The Sizewell C Project

9.115 Response by SZC Co. to RSPB's Comments at Deadline 8

September 2021

Figure 1:

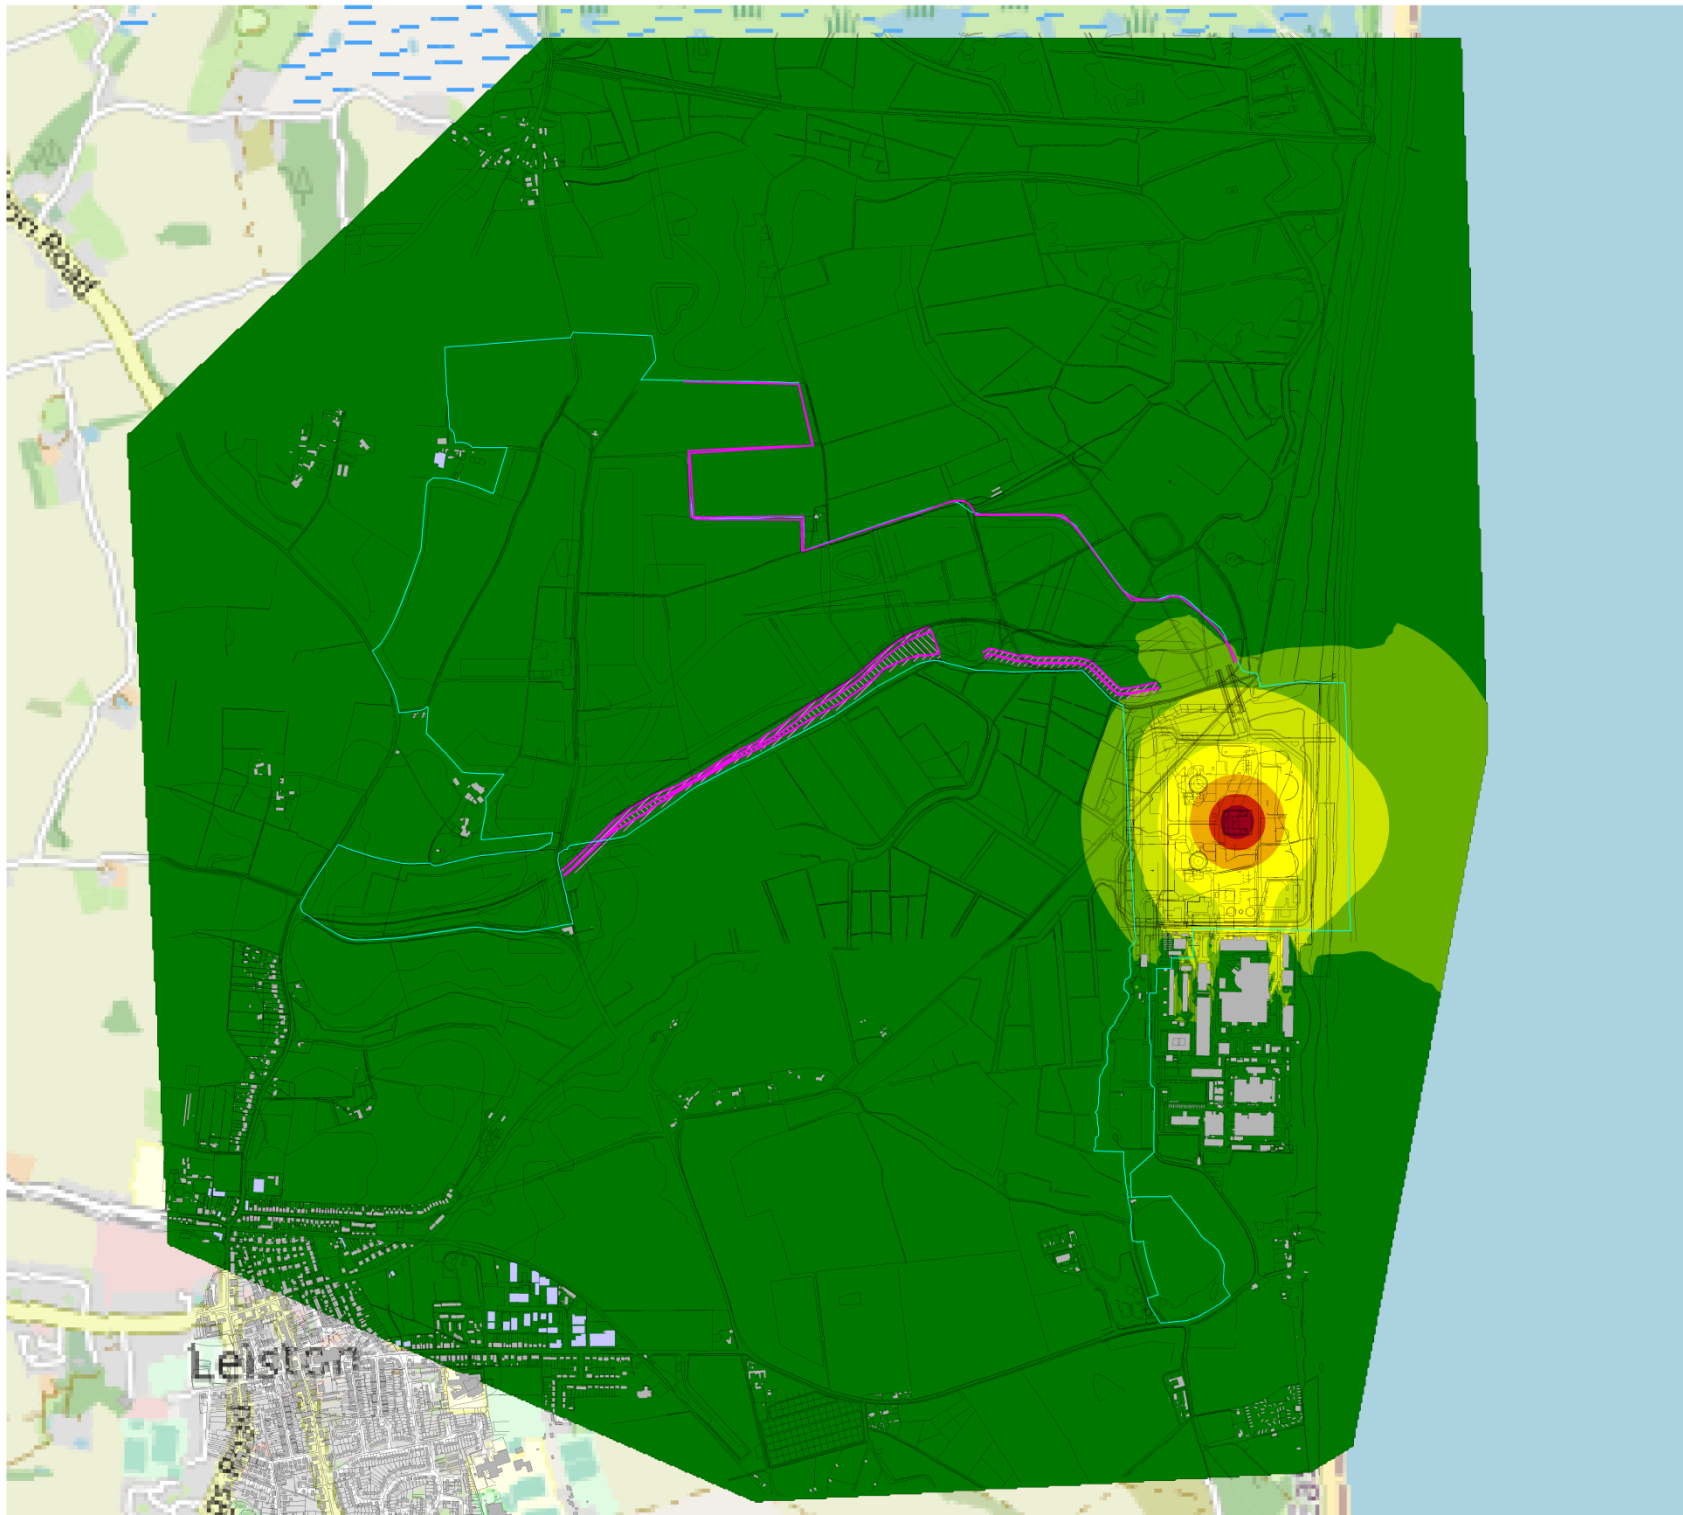
"Although we note the updates with regard effects on noise receptors in section 3.5 (e) (epage 165) of the Fourth Environmental Statement Addendum indicate that changes to noise levels at human receptors are expected to be minimal, we request that potential changes to noise levels affecting terrestrial ecological receptors (in particular waterbirds of the Minsmere-Walberswick SPA using Minsmere South Levels and Sizewell Marshes and little terns of the Minsmere-Walberswick SPA) are also assessed. We also request clarification as to whether the increases in noise levels quoted apply to all phases of construction. We understand that the additive effects of different noise sources are limited when those sources emit similar noise levels but query the additional effects of the desalination plant during phases where other construction noise is lower."

"The discussion of potential changes to noise levels affecting waterbirds of the Minsmere- Walberswick SPA (which should include those using the Minsmere South Levels and Sizewell Marshes) and little terns of the Minsmere-Walberswick SPA) appears limited in that it does not discuss all the additional noise sources arising from Change 19, noting in particular the omission of the additional HGV movements required to bring water to the construction site before the desalination plant is operational and the use of diesel generators in the early stages

1.3.8 The noise levels likely to be generated by the desalination plant are shown graphically in Figures 1 and 2, for its initial location (MCA) and second location (TCA) respectively. Since the desalination plant will operate at a constant duty at all times, the L_{Aeq} and L_{Amax} levels are considered to be equal.

1.3.13 Where the desalination plant operates at night on its own, as is likely to be the case during Phase 1 and the early parts of Phase 2 of the main development site works, the noise levels are likely to be broadly similar to the levels shown in Figure 1.

Figure 3:

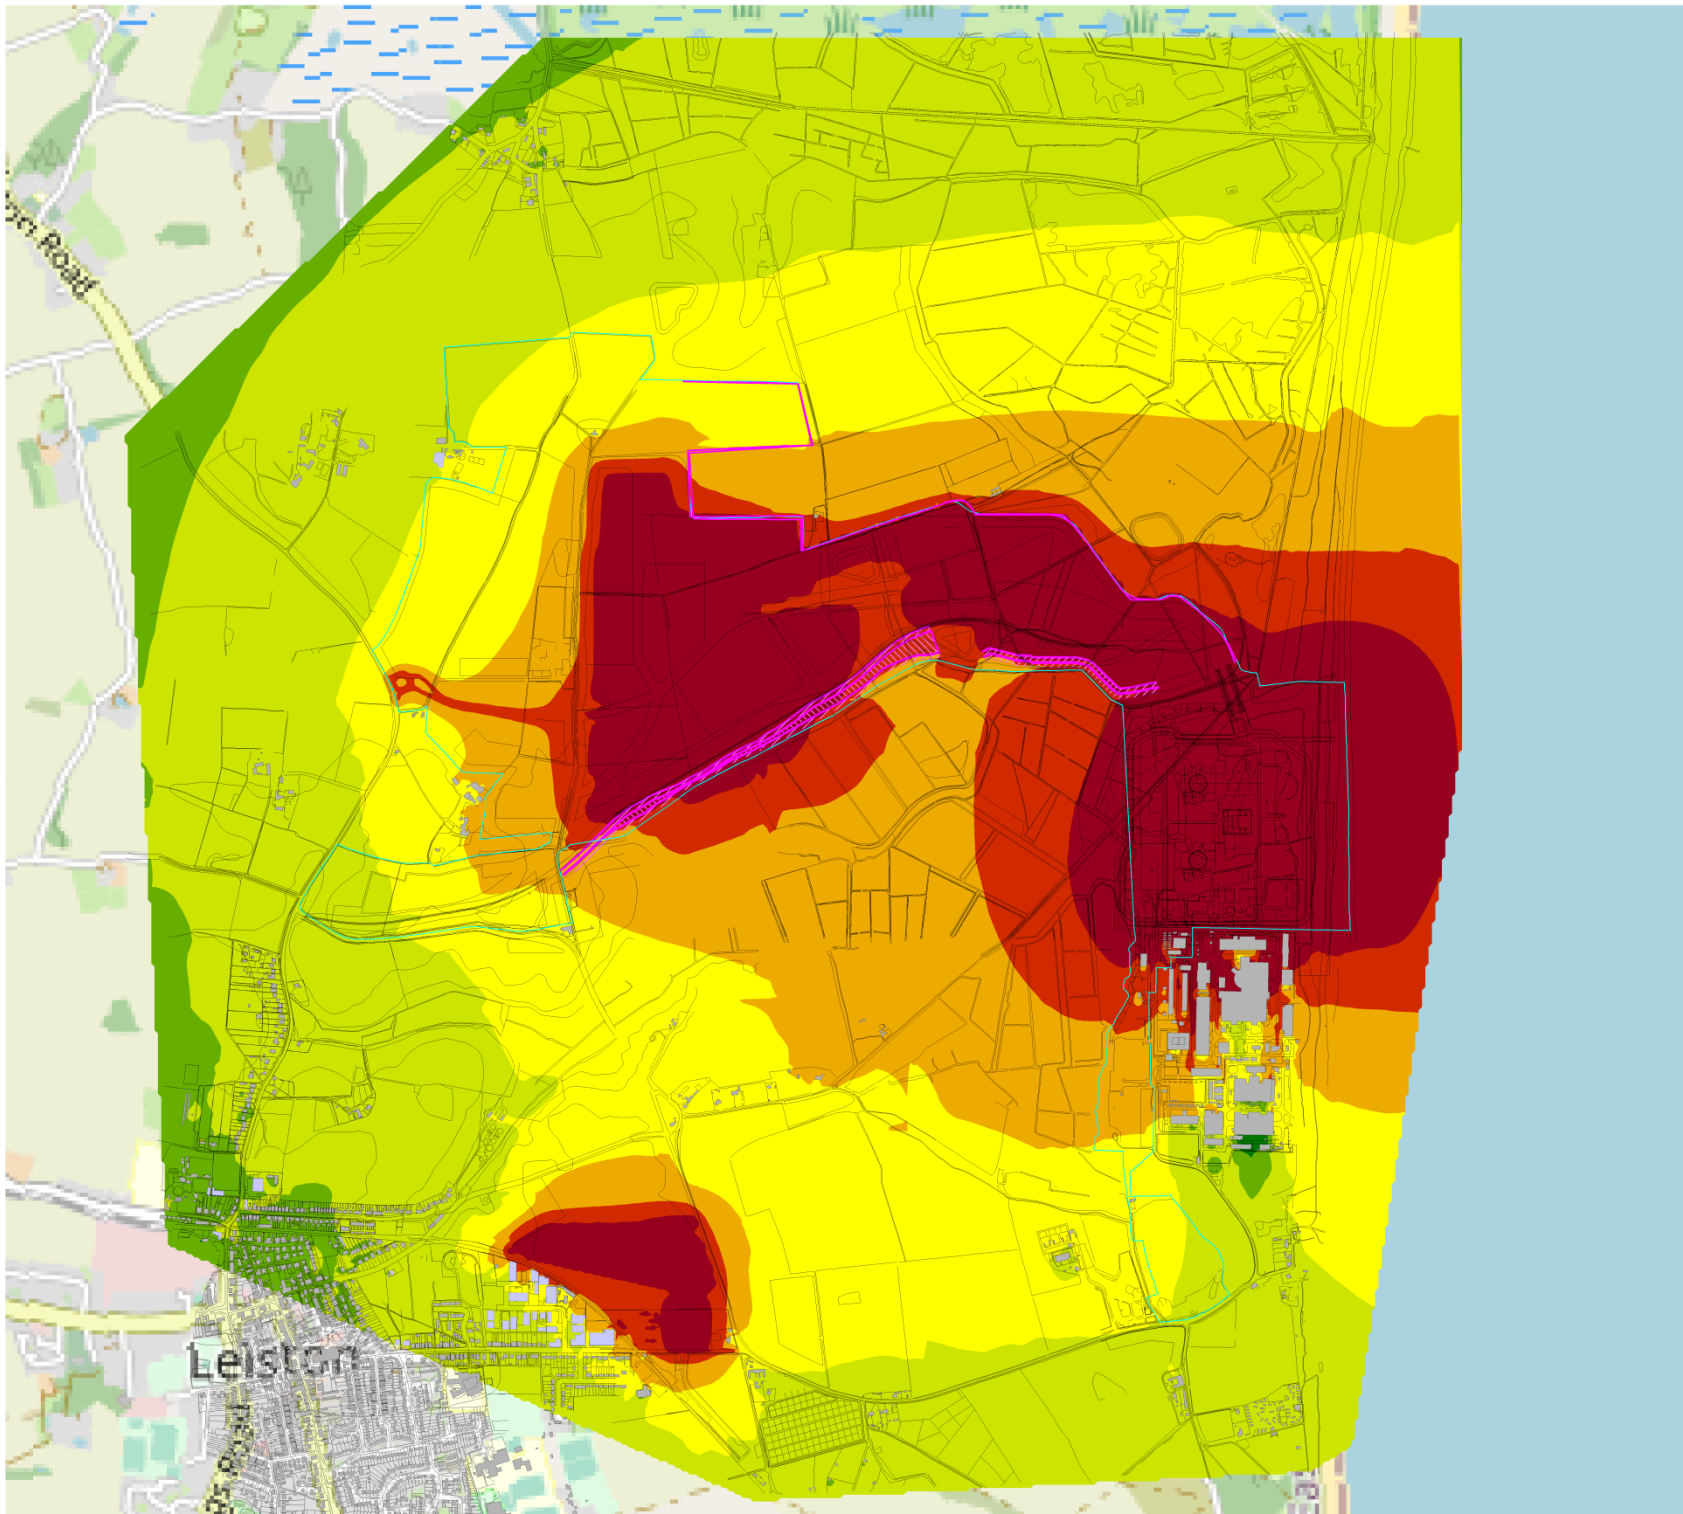
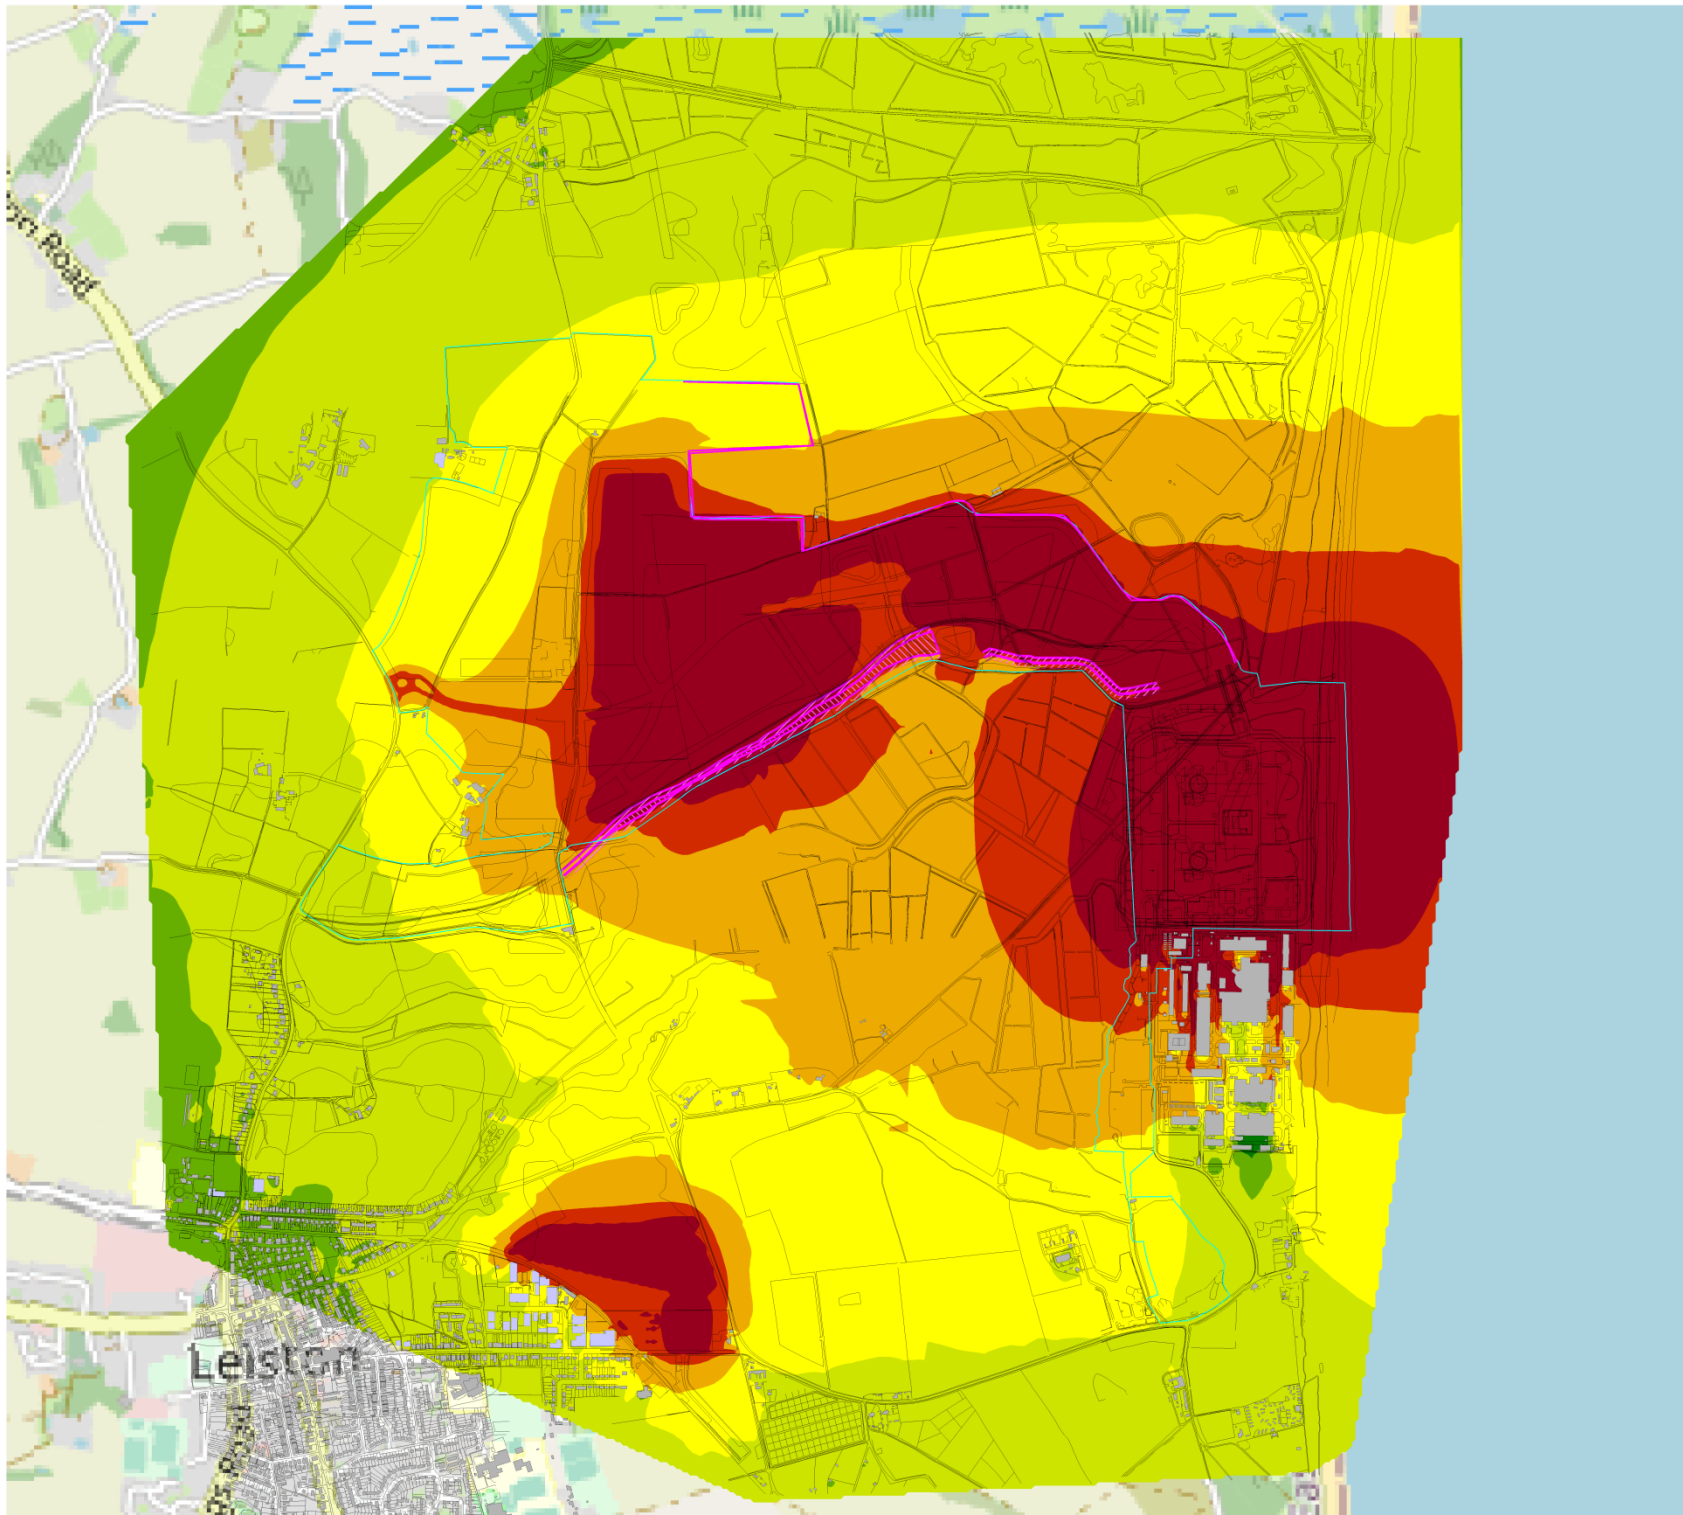
of operation of the desalination plant. We understand that the additive effects of different noise sources are limited when those sources emit similar noise levels but query the additional effects of the Change 19 during those construction phases where other construction noise is lower.”

- 1.3.20 To determine the potential for combined effects to be greater than the previously-assessed outcomes, the daytime Phase 3/4 noise levels are shown in Figure 3, with Figure 4 showing the same Phase 3/4 noise levels with the desalination plant also included.

- 1.3.21 It can be seen from Figures 3 and 4 that there is no discernible difference in the predicted noise levels as a result of the desalination plant.
